Change Order #2

Regional Linear Park Phase II (Hike & Bike Trail)

Owner: Hidalgo County Precinct #2

Project: RLPPII
Contract: C-18-199-02-12
CSJ: 0921-02-409
Limits: Hall Acres to Ridge Road

REGIONAL LINEAR PARK PROJECT
PLAN & PROFILE (LEG 1)
STA. 121+00 TO STA. 127+00

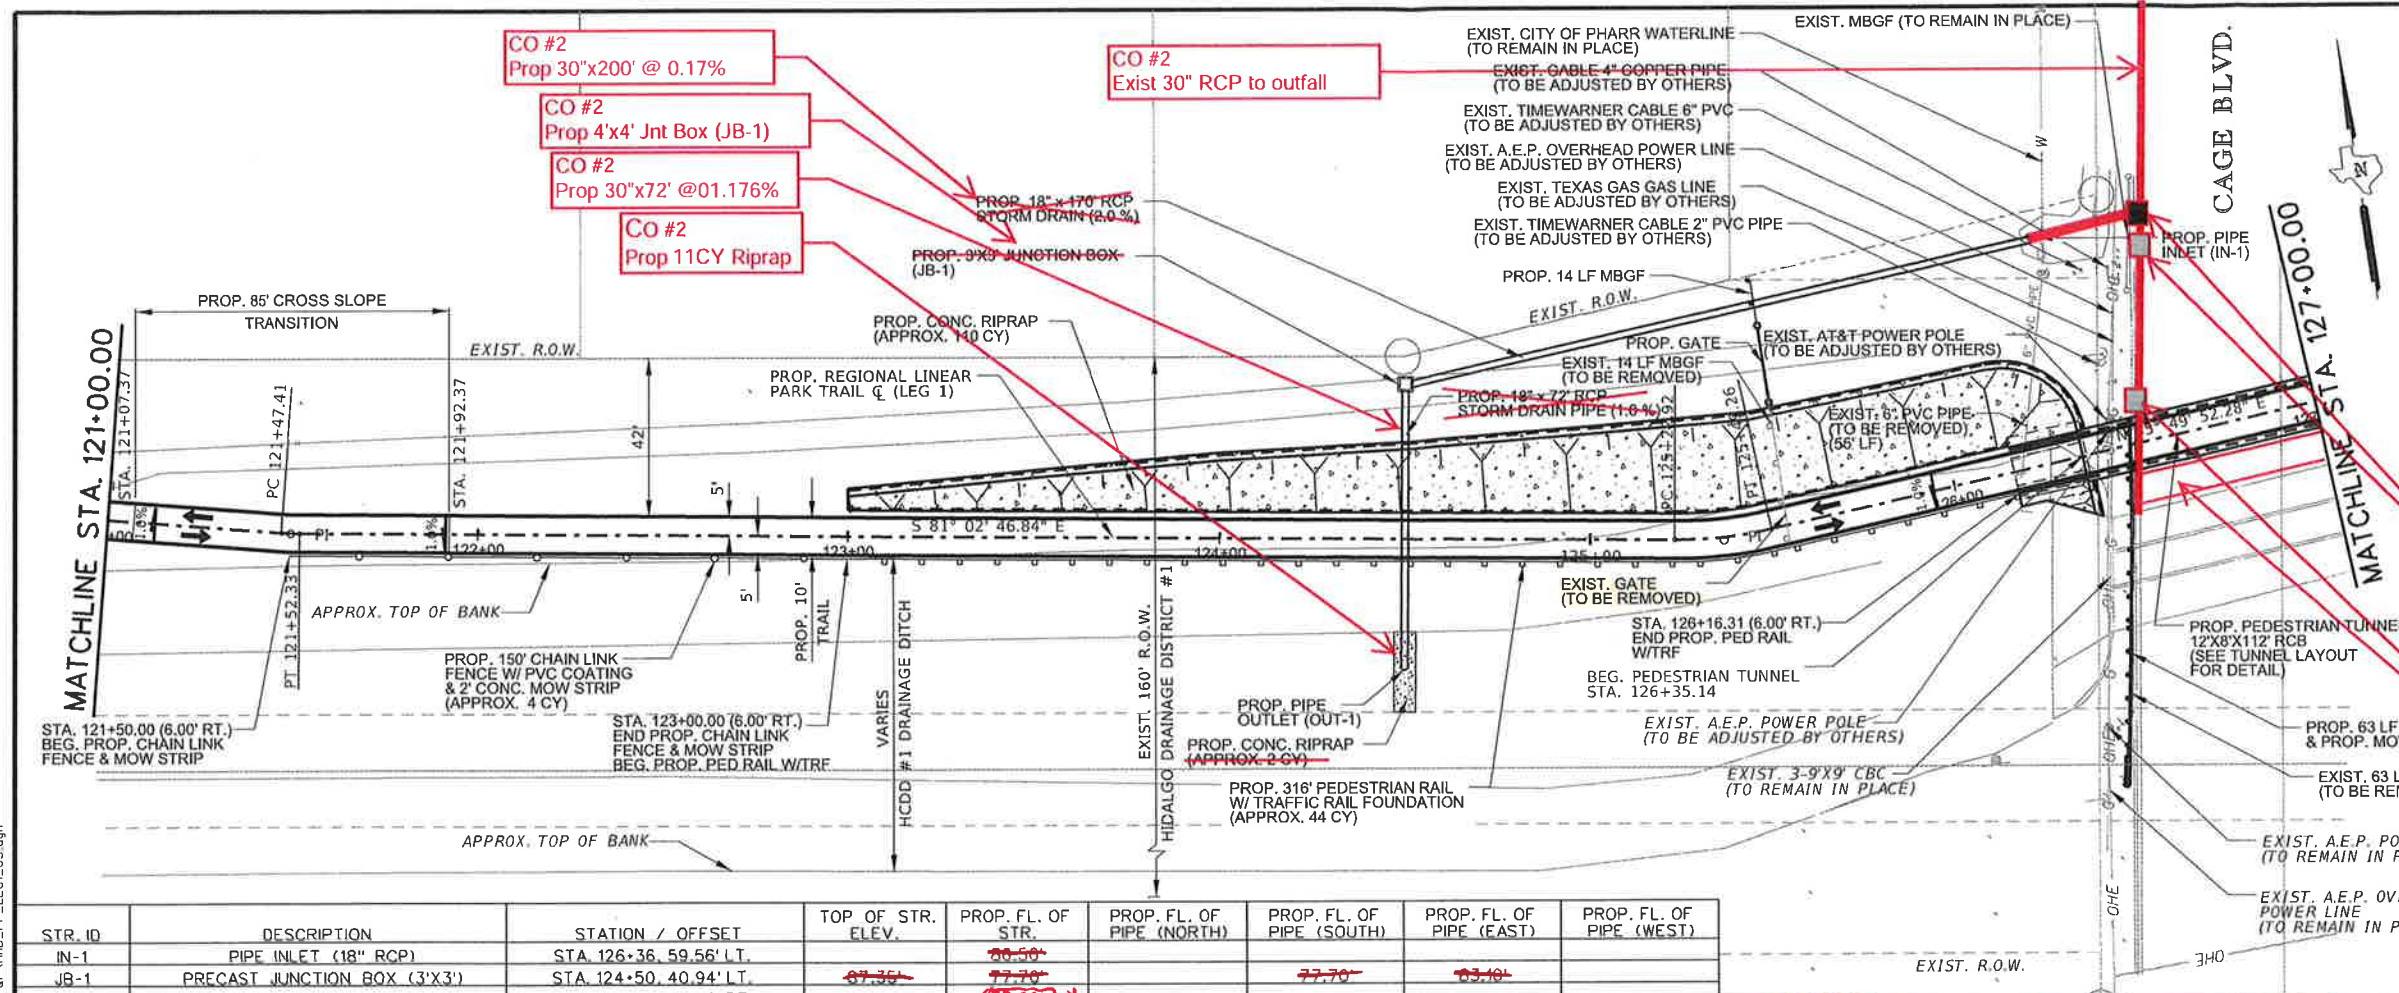
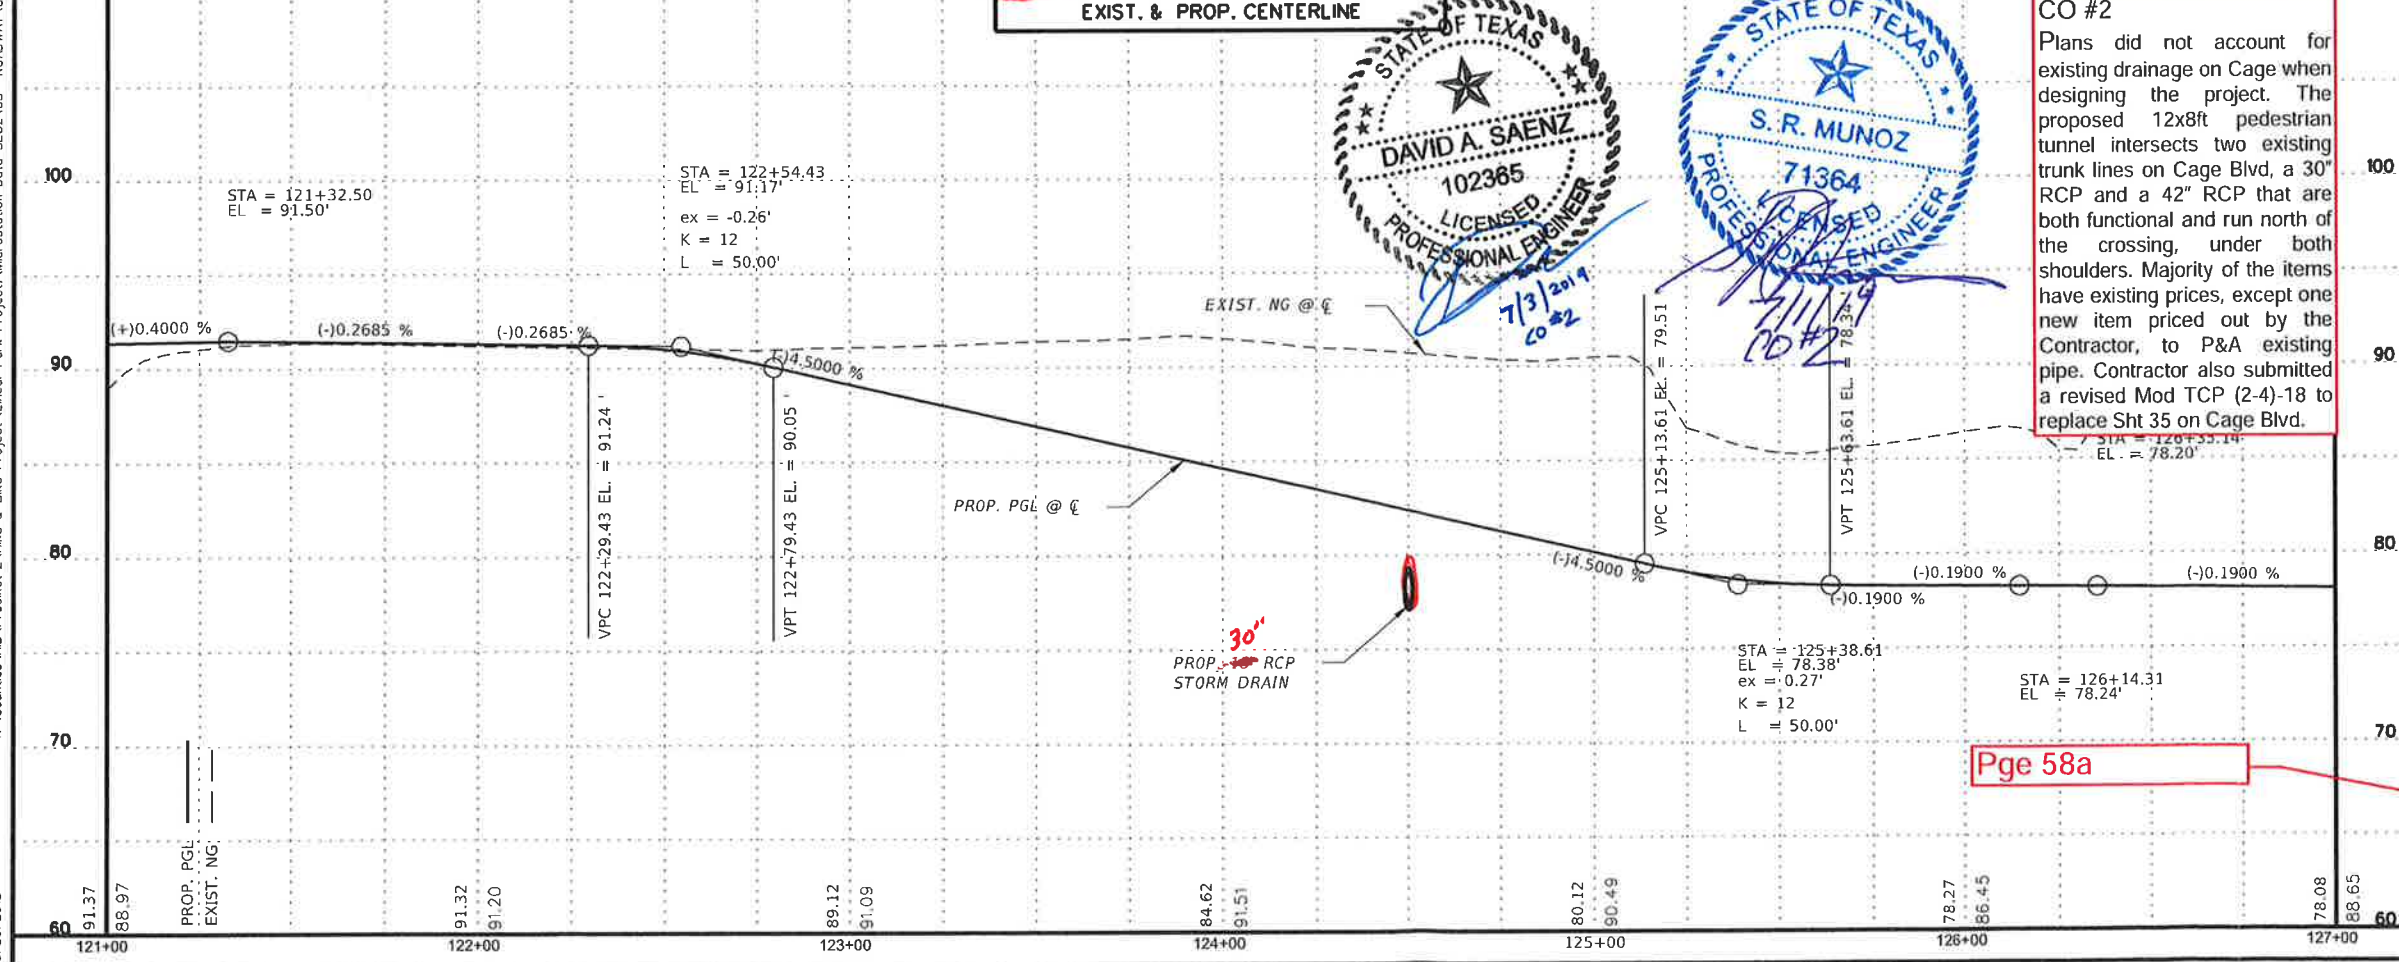
CO #2
Connect 48" RCP to outfall
Prop 6'x6' Jnt Box (JB)
Plug Ex. 42" RCP

CO #2
Rem 60" RCP x 100'
Rem 42" RCP x 20'
Plug Ex. 42" RCP

CO #2
Plans did not account for existing drainage on Cage when designing the project. The proposed 12x8ft pedestrian tunnel intersects two existing trunk lines on Cage Blvd, a 30" RCP and a 42" RCP that are both functional and run north of the crossing, under both the shoulders. Majority of the items have existing prices, except one new item priced out by the Contractor, to P&A existing pipe. Contractor also submitted a revised Mod TCP (2-4)-18 to replace Sht 35 on Cage Blvd.

REGIONAL LINEAR PARK PROJECT
 PLAN & PROFILE (LEG 1)
 STA. 127+00 TO STA. 133+00

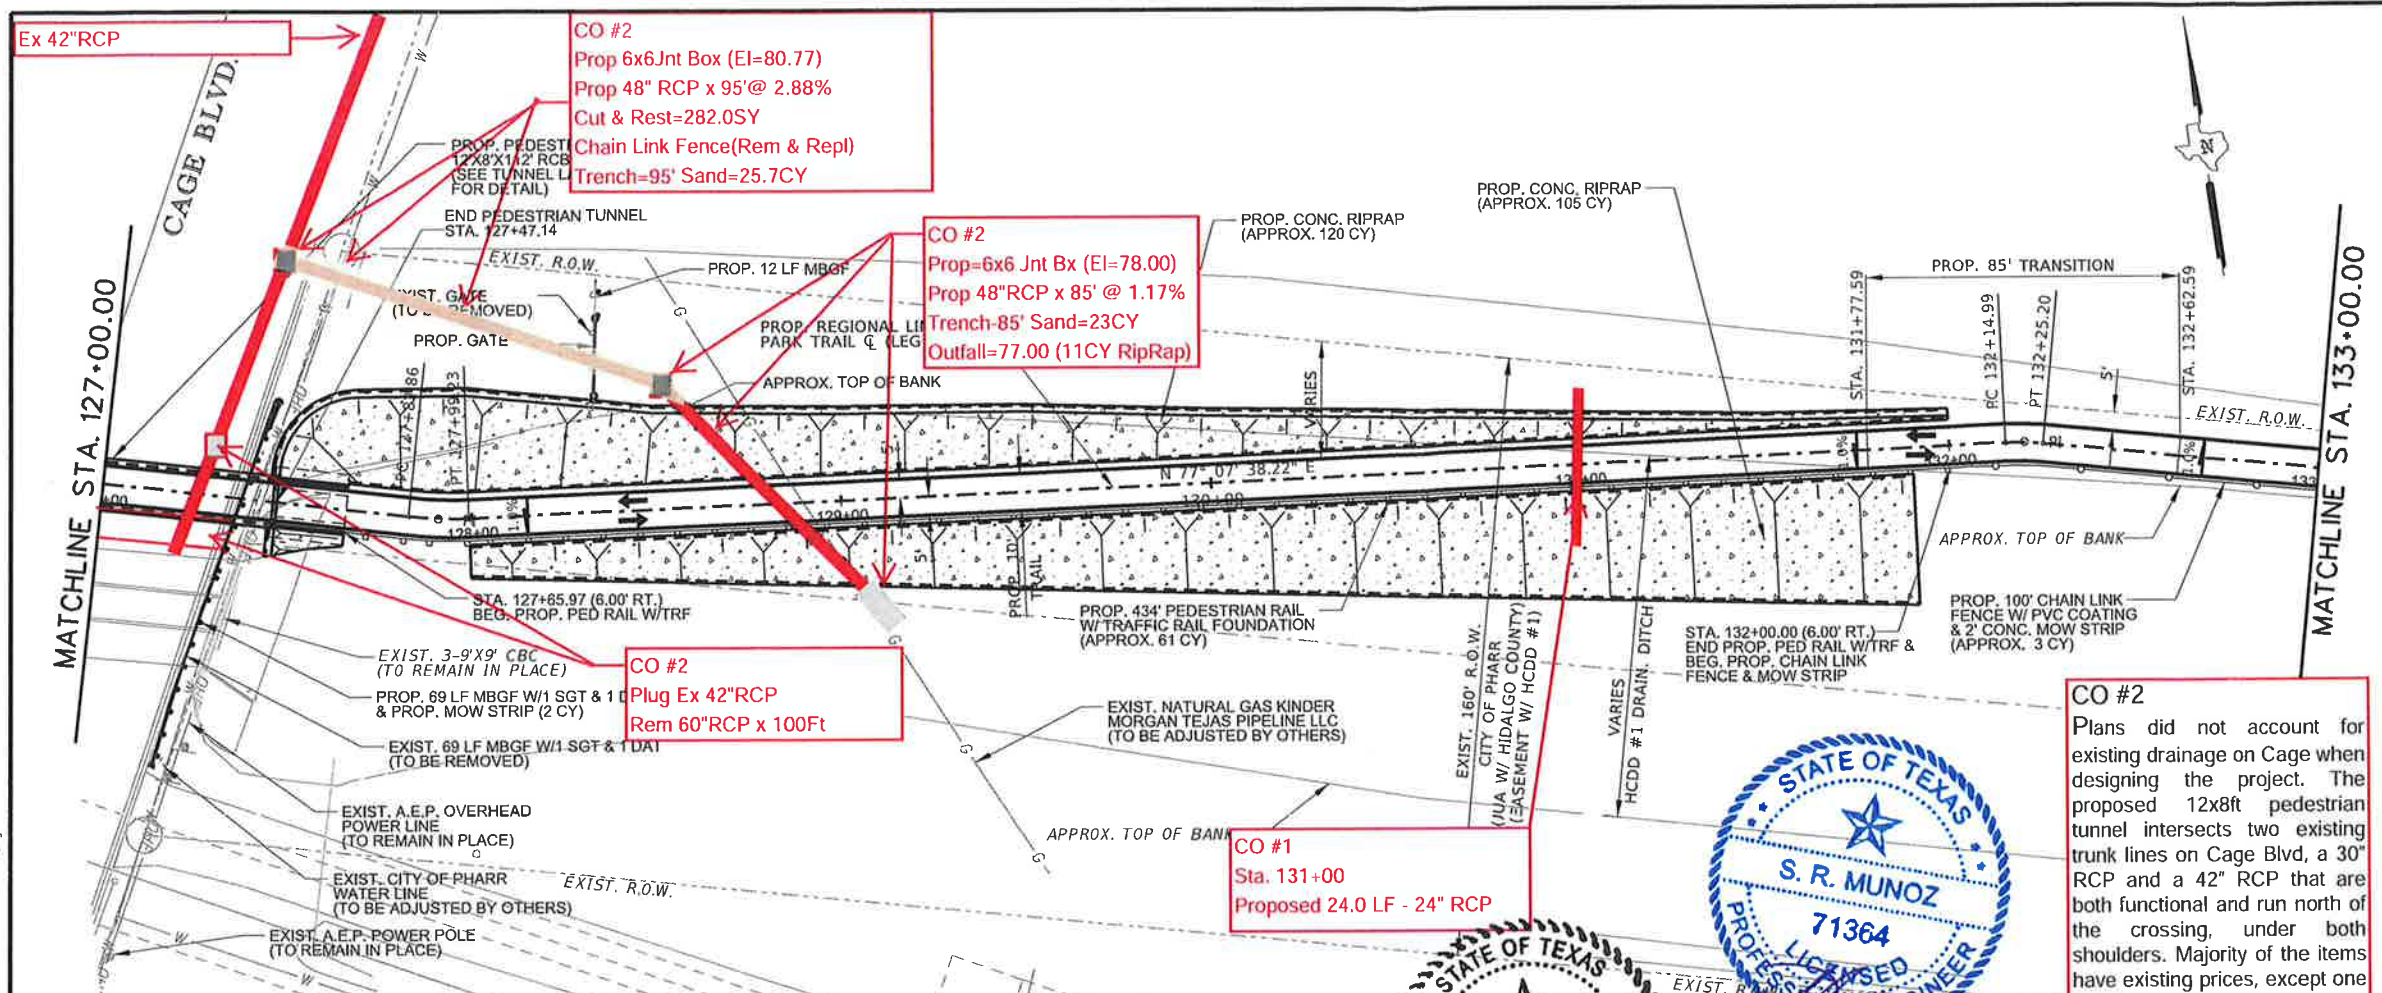
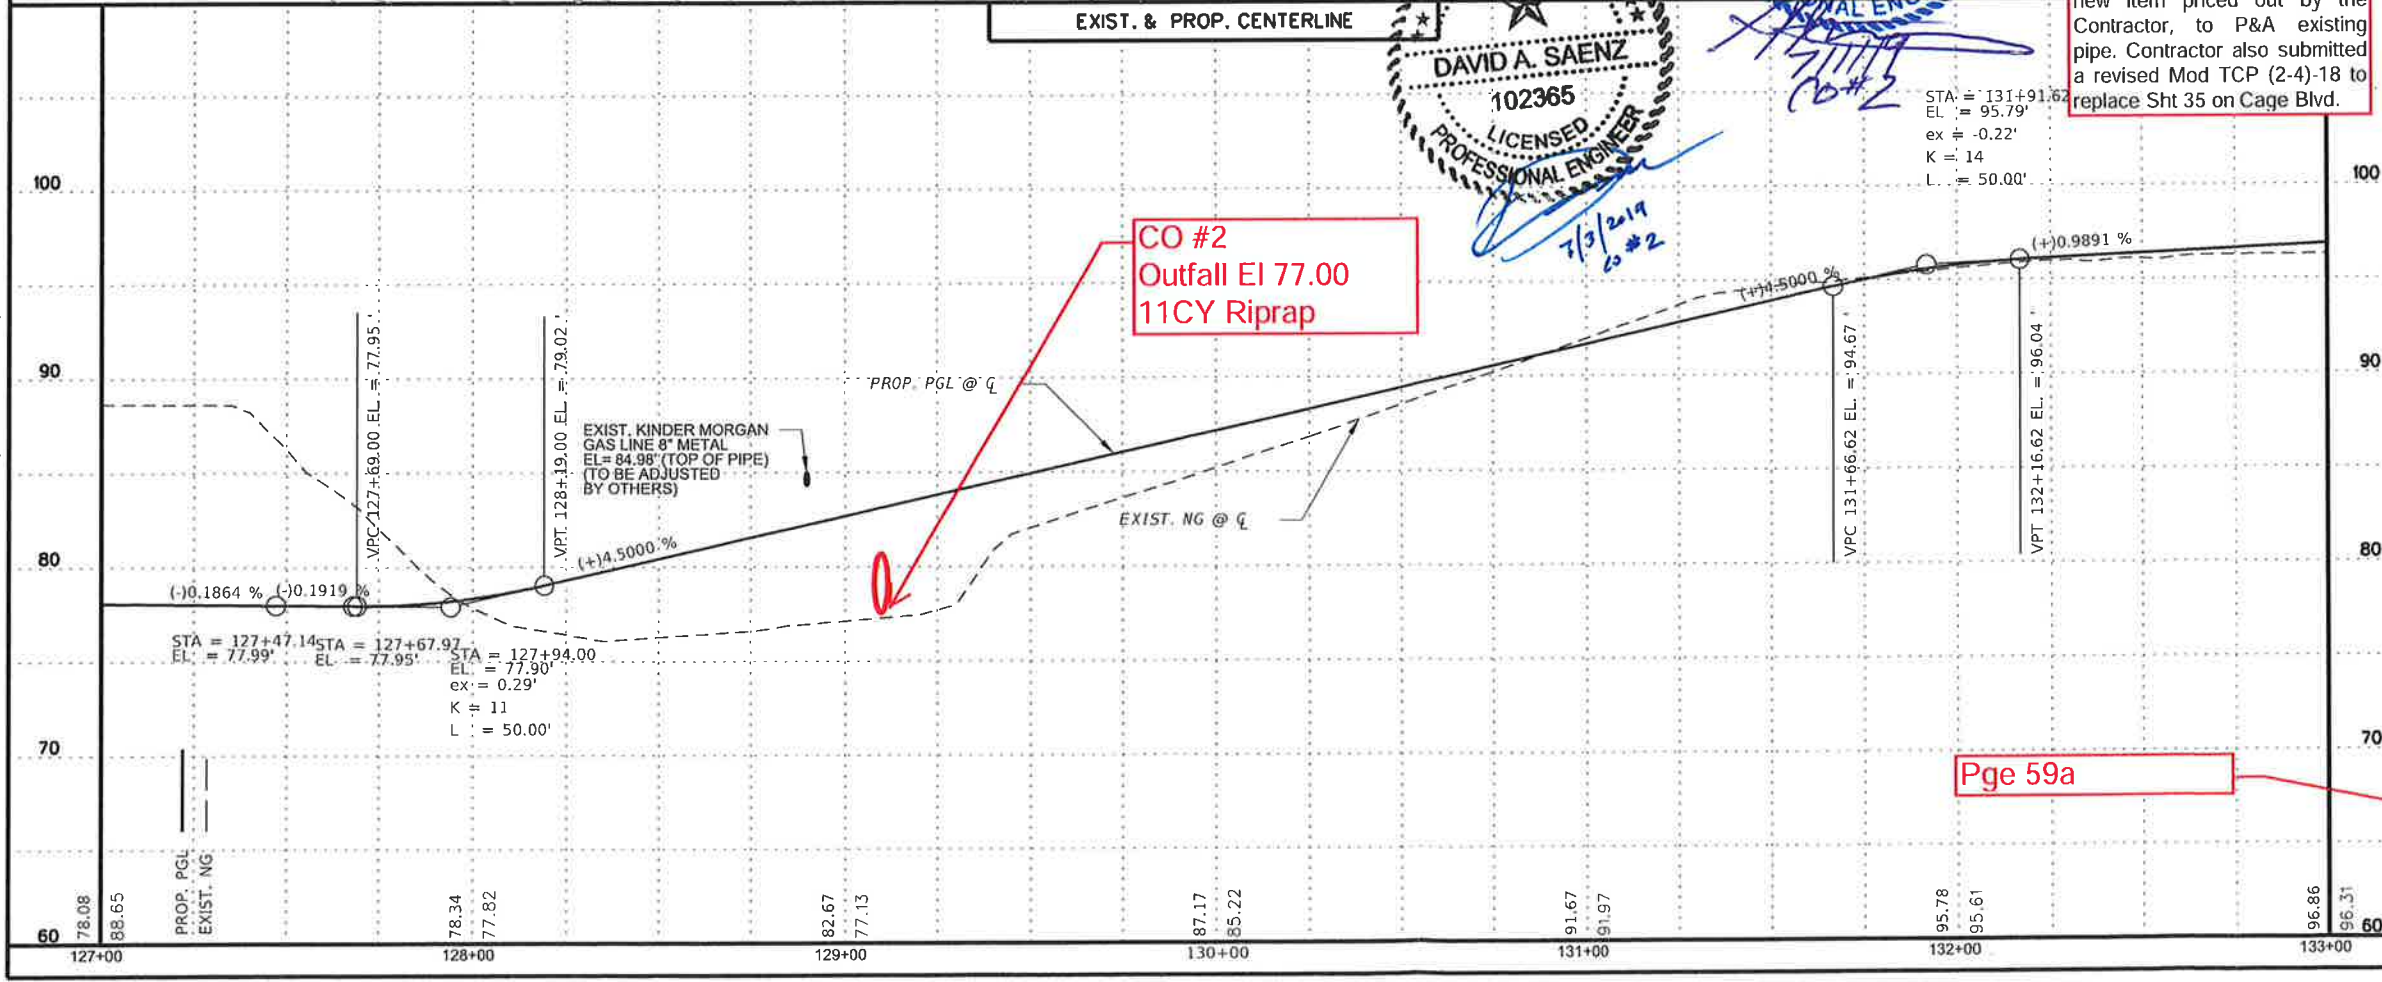
7/3/2019
 CO #2
